# Memorandum

**To:** UUFCA Board of Directors  
**From:** Duncan Brown, Land and Site Committee  
**Subject:** **Proposed Roundabout Land Acquisition**

Recommended Skyliners Access

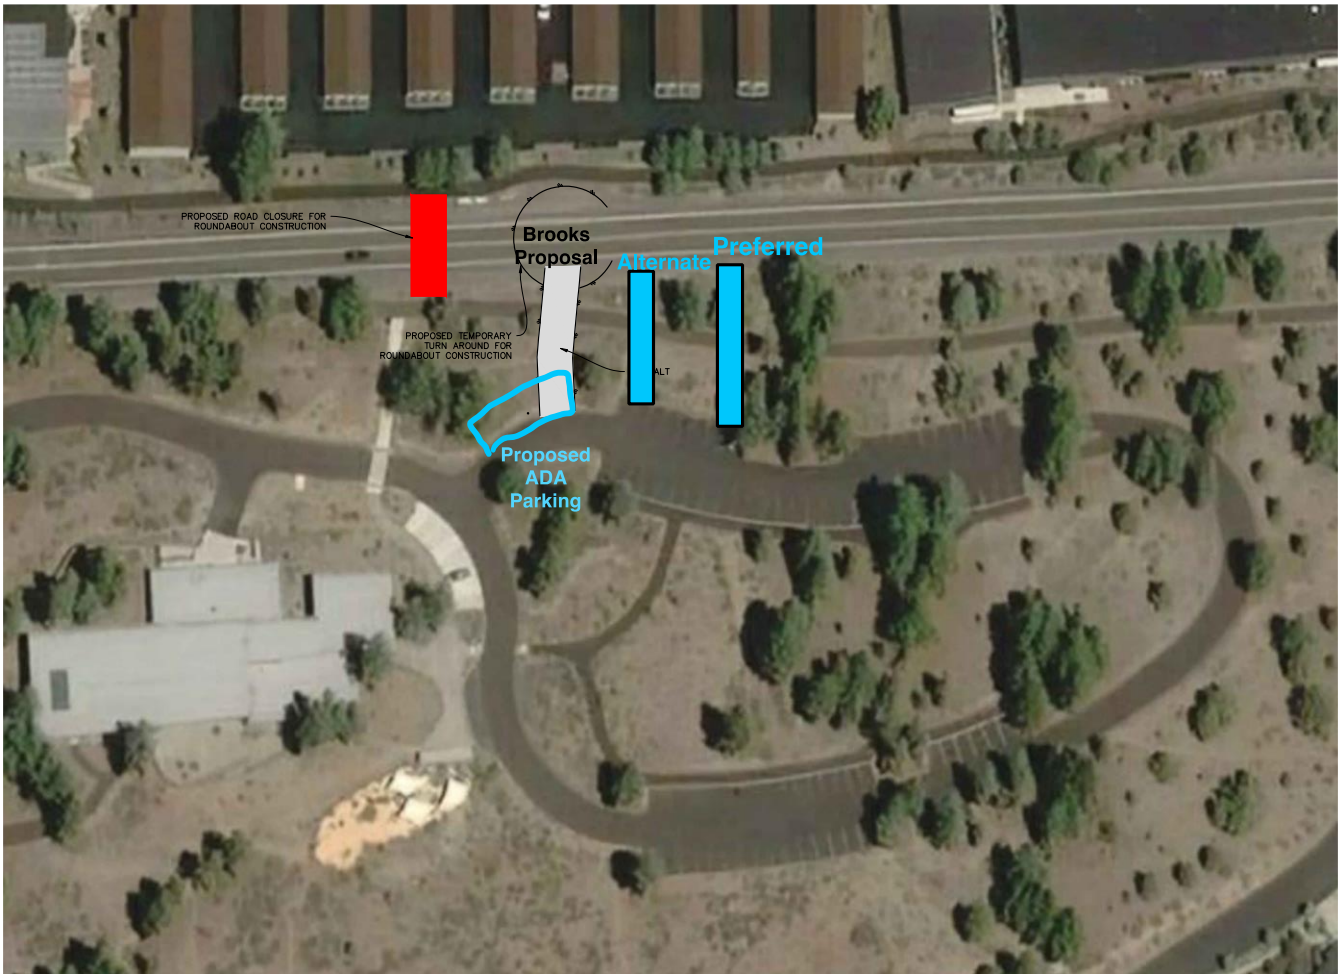
Brooks Resources proposes locating the second access point along the entry drive to the upper parking area. However, this location has been reserved and planned for additional ADA parking spaces, which were proposed and went as far as City permit review just prior to the COVID pandemic. A more functional location for the access would be east, although Skyliners Road begins to descend relative to the onsite parking elevation, which could create a steep north-facing access drive, as well as requiring major impacts to the bicycle/pedestrian path if located more than a couple of hundred feet further east.

Two alternative access drive locations from the upper parking area are suggested (see attached exhibit), which would preserve the possibility of ADA parking expansion. Both would intersect with Skyliners Road before it begins its steeper descent to the east, minimizing steepness. Two parking spaces would need to be eliminated in order to provide the connection with the onsite parking area, but restriping in that section could restore at least one of them without much trouble.

I recommend that the preferred second access point for onsite parking be at the location identified as "Preferred" on the attached "Recommended Skyliners Access" diagram or, if that is unfeasible due to physical constraints, the "Alternate" be selected. I also recommend that the access drive be

engineered and constructed to permanent access drive standards for two-way traffic and that a gate similar to that found onsite for the fire access be installed.
